**STAFF REPORT TO THE MARIN COUNTY
PLANNING COMMISSION
Brandon Sullivan et al Appeal of the Sasan Site Plan Review Approval**

Recommendation: Deny the appeal and sustain the Community Development Agency's action to approve the Sasan Site Plan Review

Hearing Date: August 23, 2021

Owner(s): Tim and Beth Sasan
Assessor's Parcel No(s): 177-172-10 and -20
Property Address: Vacant Parcel Historically Referred to as 187 Sacramento Avenue, San Anselmo

Form: MCFD Plan Review
Form

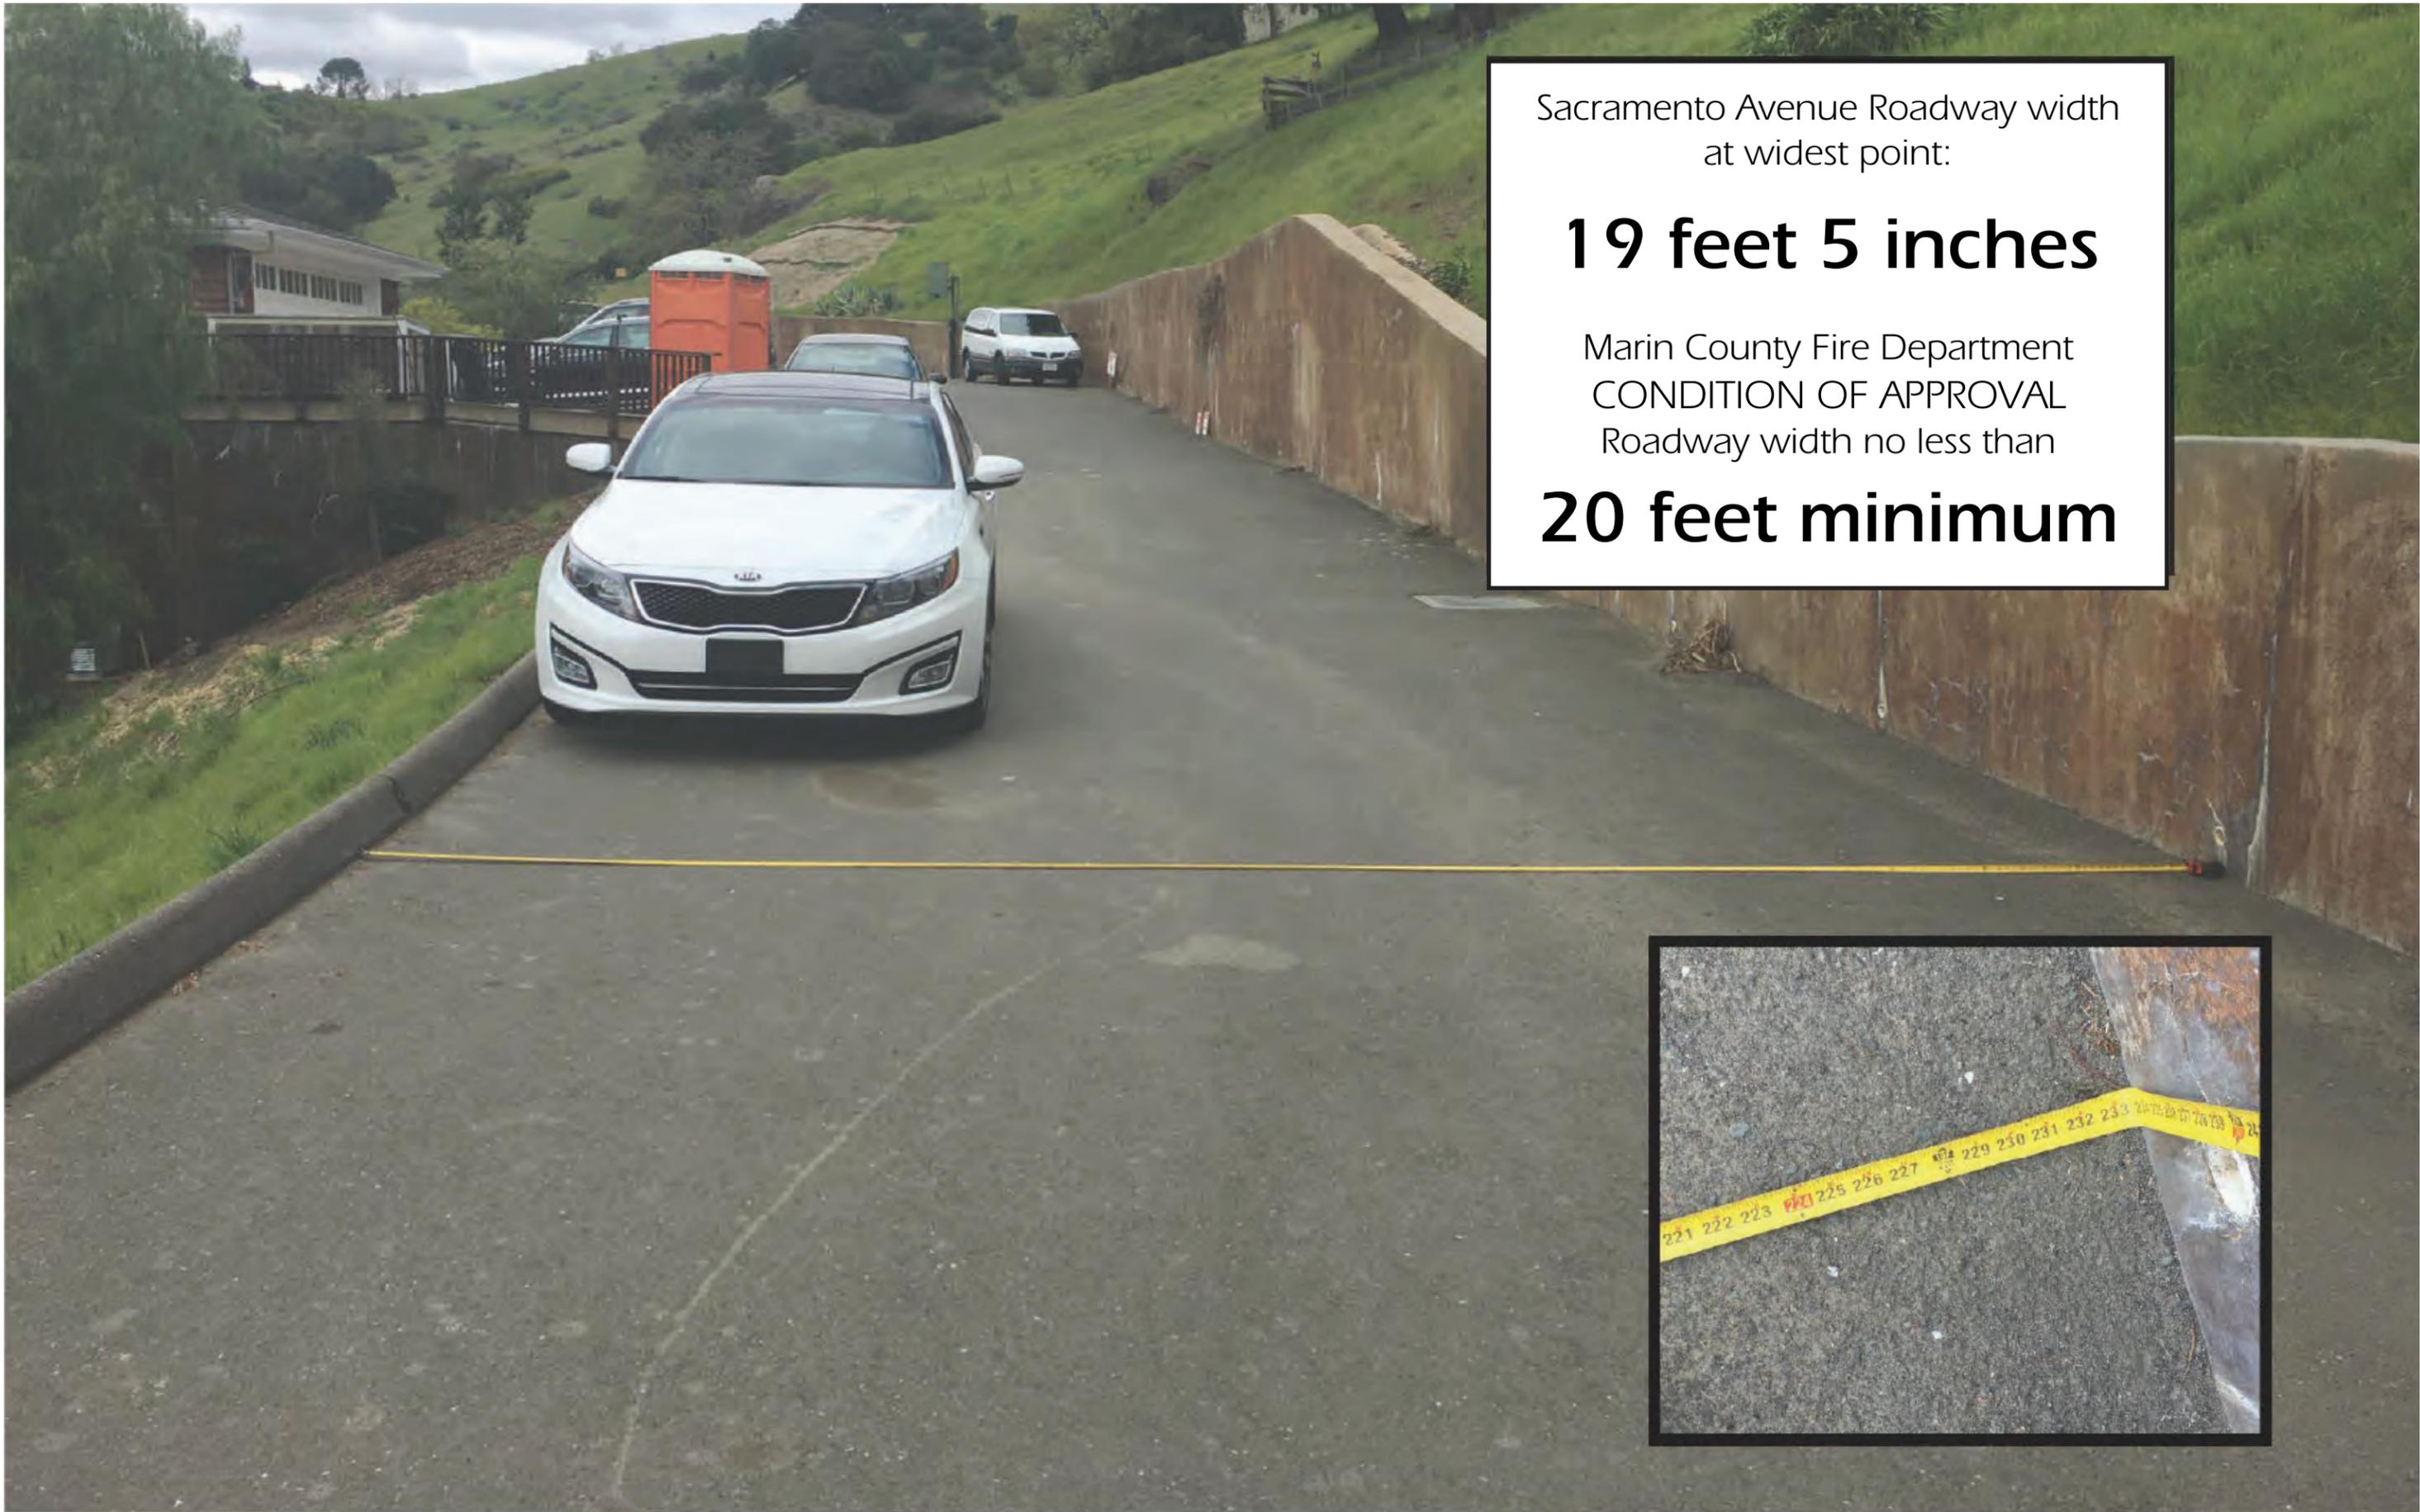
Inspection Description:
Based on the 2013 California Building and Fire Codes, along with current Marin County Fire Department Standards.
Inspection Topics:
Planning Division Review
Automatic Residential Fire Sprinkler System Is Required per NFPA 13D An automatic residential fire sprinkler system is required to be installed in all new residences including garages conforming to NFPA Std. 13D, Fire Protection Standard #401, and as modified by the Fire Marshal. Plans and hydraulic calculations shall be submitted to the Fire Marshal for review prior to installation. Contact the North Marin Water District or Marin Municipal Water District (as applicable) should an upgrade for the domestic water meter be needed. Additional sizing may be required due to available pressures and fire flow. The above requirement may be waived provided the new and existing remodel and addition does not exceed 50% of the total existing floor area. Status: Condition of Approval Notes: See above.

Fire Hydrants Required. (Upgrade) The existing fire hydrant nearest the structure and located by the Fire Marshal shall have the body upgraded to have at least one 4 and one half inch and one 2 and one half inch outlet. Installation shall conform to the specifications of the Marin Municipal Water District or North Marin Water District (as applicable). Status: Condition of Approval Notes: Provide location, type and flow rate of nearest municipal fire hydrant.
Roadways and Driveways, Grade. Proposed roads and driveways shall not exceed 18% grade. Status: Condition of Approval Notes: Provide grade profile of driveway/road and fire apparatus turnaround.
Roadways and Driveways Minimum Requirements (Prior to Lumber Delivery or Framing). Roadways shall be not less than 20 feet wide capable of accommodating a 60,000 GVW and driveways not less than 16 feet wide capable of accommodating a 40,000 GVW, all weather surface (AC Paving or concrete), unobstructed, and shall be installed prior to lumber delivery or framing. Status: Condition of Approval Notes: See above.

SACRAMENTO AVENUE
 APN 177-172-09, 10, 18 & 20
SACRAMENTO AVENUE SAN ANSELMO, MARIN COUNTY
TOPOGRAPHIC MAP

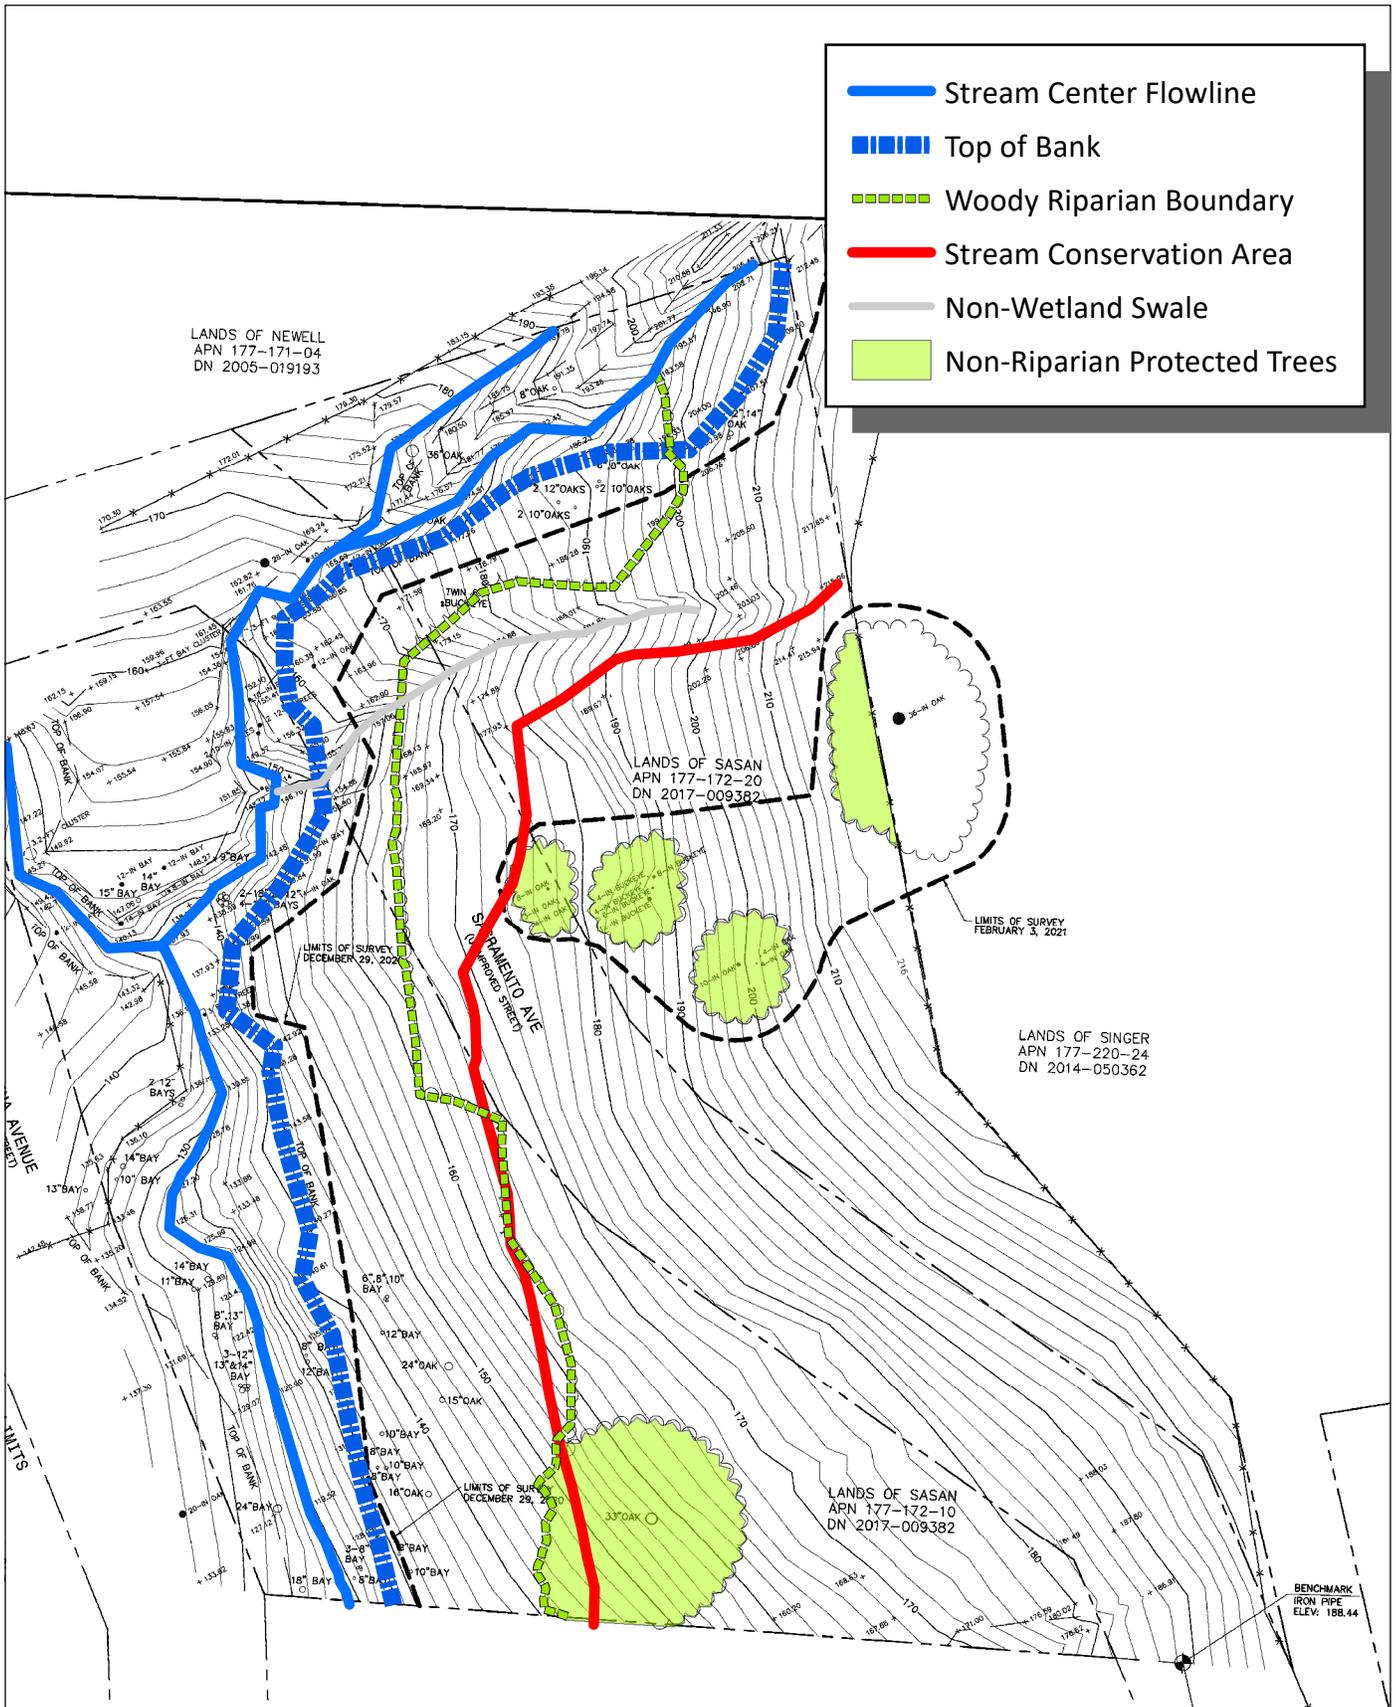
In addition to the stream shown on LSA Figure 1, two additional ephemeral stream channels are converging on the project site along its northern boundary, as shown on the BKF Topographic Map Exhibit 1 (Attachment A), FCS Exhibit 1, Biological Constraints Analysis Map (Attachment B), and Photo 1 (Attachment C) Because of presence of riparian vegetation for more than 100 feet along this stream (within and upstream from the project site), CWA Policy BIO 4.1 Restricted Land Use in Stream Conservation Areas (i.e., implementation of an SCA) would be applicable.

Additionally, FCS evaluated a vegetated swale on the northern portion of the property. This swale runs east to west for approximately 140 feet, terminating at the main blue-line stream, as shown on FCS Exhibit 1, and Photos 2 and 3. At the time of the survey, the swale did not show evidence of substantial concentrated flow, e.g., no ordinary high-water mark or other parameters typically indicative of a stream (including ephemeral headwater streams) were present.³ This lack of concentrated flow appears relevant because an atmospheric river system passed over the area that added approximately 2.5 inches of rain within the 3 days prior to the survey, which would have resulted in flow indicators if the feature functioned as an ephemeral headwater stream.
